Application for Licence

Licence Number	L9342/2022/1
Applicant	Doral Mineral Sands Pty Ltd
ACN	096 342 451
File number	DER2022/000142
Premises	Yalyalup Mineral Sands Mine South of Princefield Road; West of Ludlow-Hithegreen Road; North of Yalyalup road; and East of Wonnerup South Road YALYALUP WA Legal description – Tenement M70/1400 and as described in Schedule 2 of the issued licence.
Date of report	08 March 2023
Decision	Licence granted

Figure 1: Distance to sensitive receptors

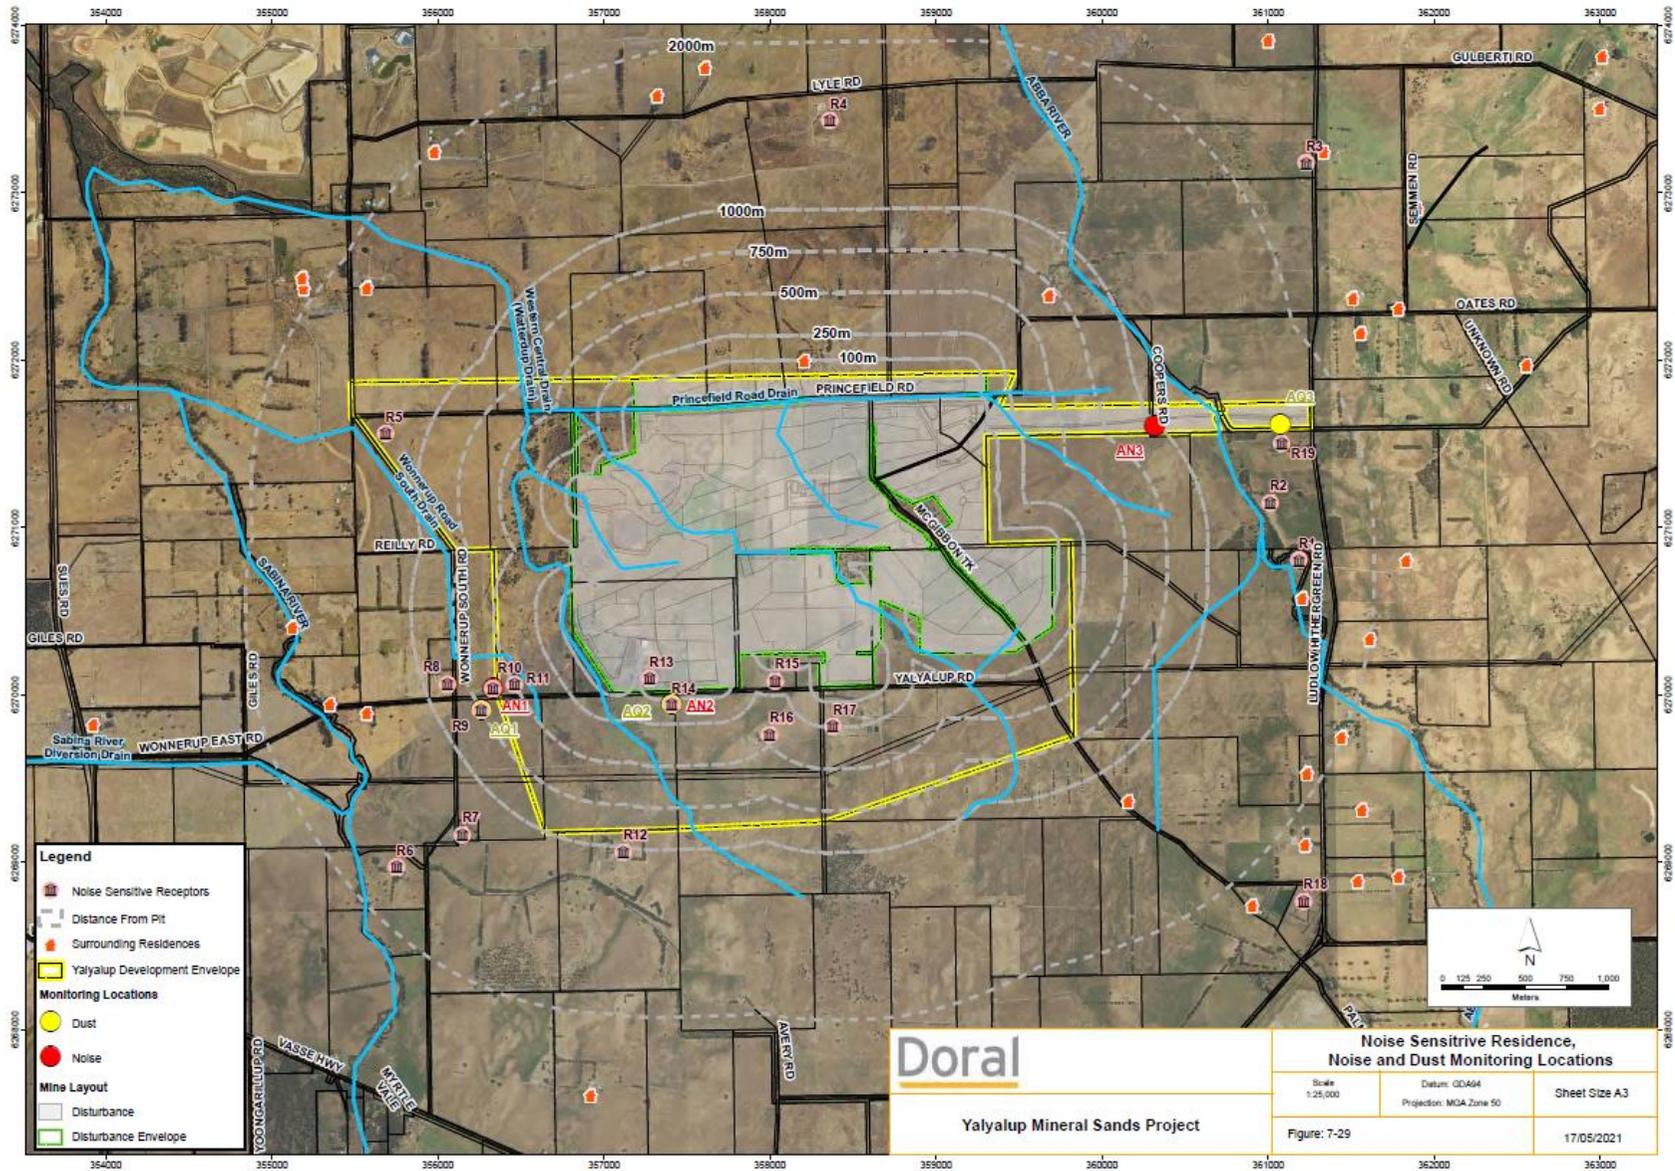
There is potential for generation of dust from mineral sands mining, screening and associated earthworks, as well as from exposed cleared areas. Dust impacts to vegetation are likely to be minimal given the short-term nature of mineral sands operations and the relatively high local rainfall. Amenity and health impacts to residential receptors may occur as there are a significant number of rural residences within 1km of the Premises (see Figure 1).
